STATE OF NORTH CAROLINA  
DEPARTMENT OF TRANSPORTATION

Subject: **REVISION to Application for Individual Section 404 Permit and 401 Certification** for the widening of US 321 from SR 1500 (Blackberry Road) to US 221 at Blowing Rock; Watauga and Caldwell Counties; State Project No. 6.739001T; NCDOT Division 11; TIP No. R-2237C, WBS Element No. 34402.2.6

This Application Revision is being submitted to augment the previously submitted application referenced above. This Revision includes responses to comments received in letters from the DWQ and from the USACE, as referenced above, and corrections/clarifications to the original application. This Revision application package consists of the cover letter, attachments for the responses to the USACE comments, a revised EEP acceptance letter, and Revised Permit Drawing Sheets (including revised Wetland Permit Impact Summary sheets) along with the applicable corresponding revised roadway plan sheets.

PROJECT REFERENCE NO.	SHEET NO.
R-2237C	16
R/W SHEET NO.	16
ROADWAY DESIGN ENGINEER	HYDRAULICS ENGINEER
PRELIMINARY PLANS	
DO NOT USE FOR CONSTRUCTION	
REVISED	10-5-10

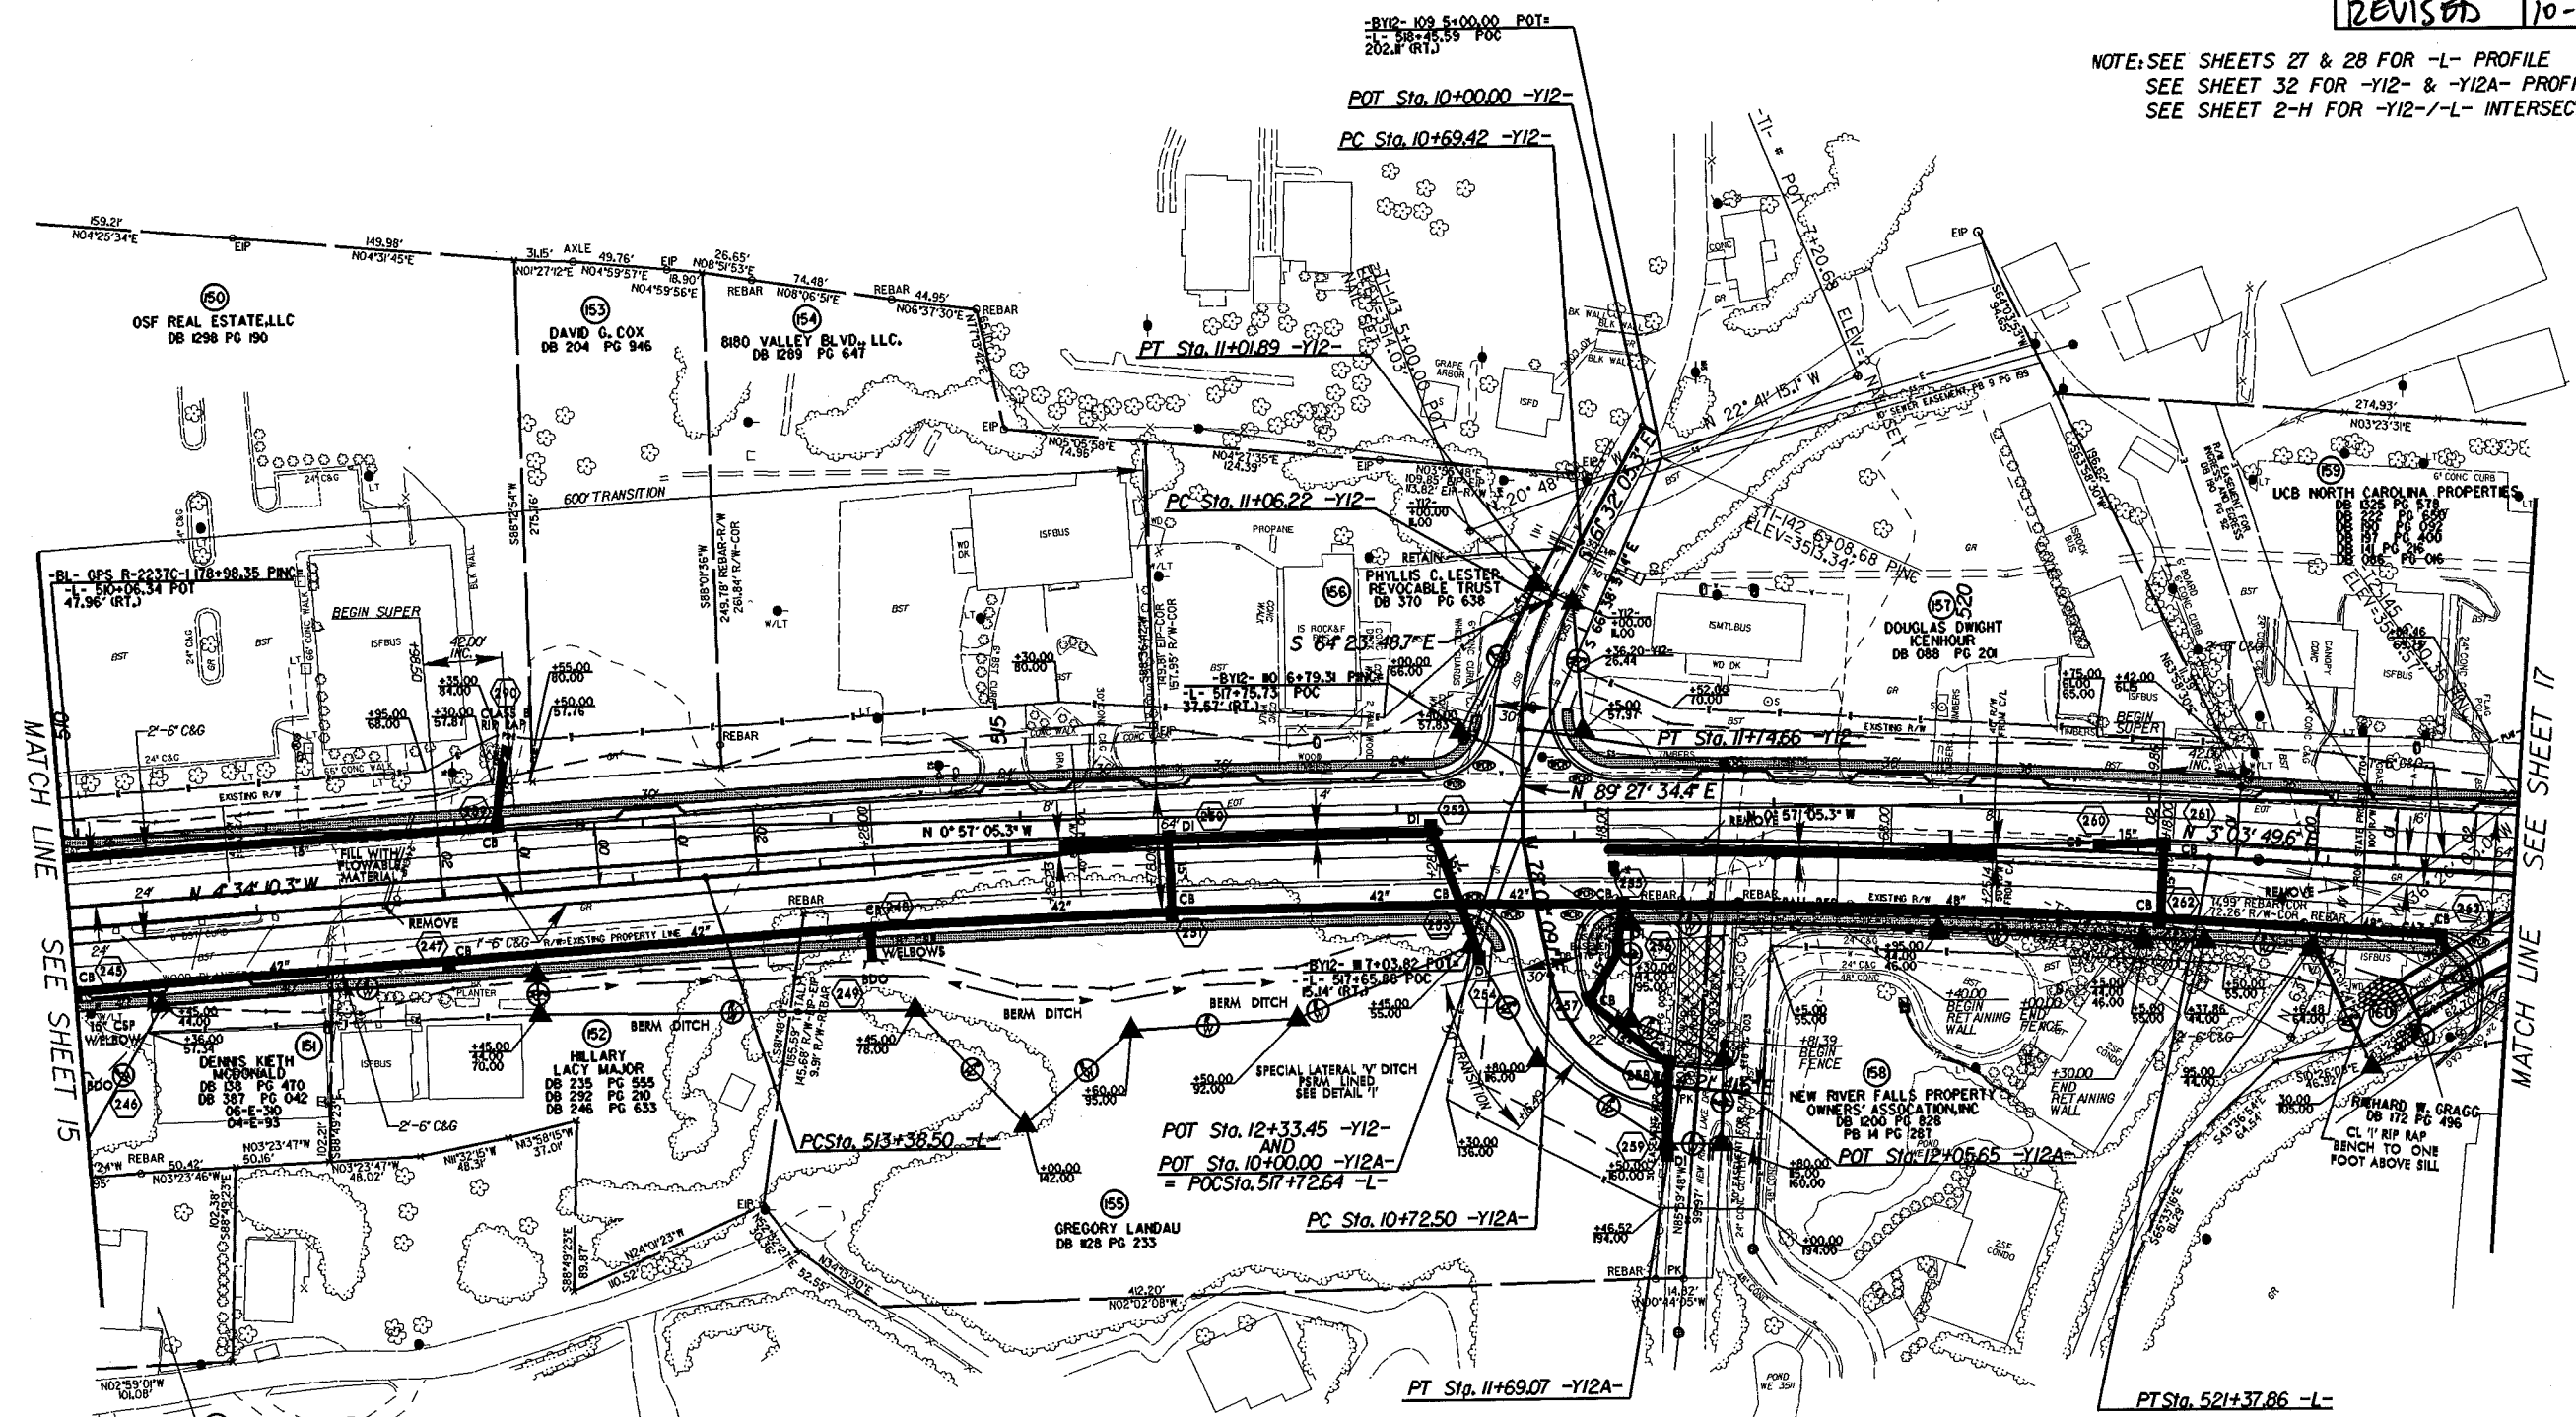
NCDOT has revised the culvert at Site VII. The revision includes the placement of a riprap bench to a height of one foot above the southern sill of the culvert. See Revised Permit Drawing Sheets 24-26 of 45, and 40 of 45, and the applicable corresponding revised roadway plan sheet number 16. There is no change in impacts.
